## Warning relating to air pistols – Compressed Air Cylinders Model 2/WALTHER 0,085 ccm – Manufacturing period 2000/2001

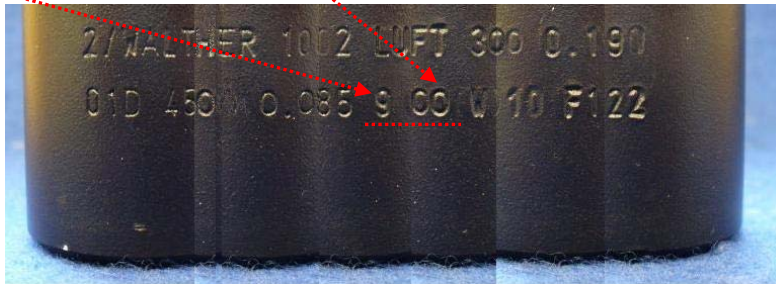
In the course of the analysis following an accident with a burst older aluminium- compressed air cylinder a defect in the raw material has now been ascertained for the first time. The raw material batch from which the burst cylinder came was supplied to WALTHER in 2000 and the cylinders were sold up to 2001. We cannot exclude that other cylinders from this batch may also be affected by this fault.

**The cylinders are liable (not only when being filled but also when in use) to burst and cause serious injury in view of the high pressure.**

For this reason, air pistols – compressed air cylinders Model 2/WALTHER 0,085 ccm with the imprinted test date between **6 00 and 6 01** (see illustration) **2000/2001** may no longer be used and must be immediately depressurised.

We will, if desired, replace the affected air pistols – compressed air cylinders 2000/2001 by a new cartridge at the **special price of €48,- (including VAT)**.
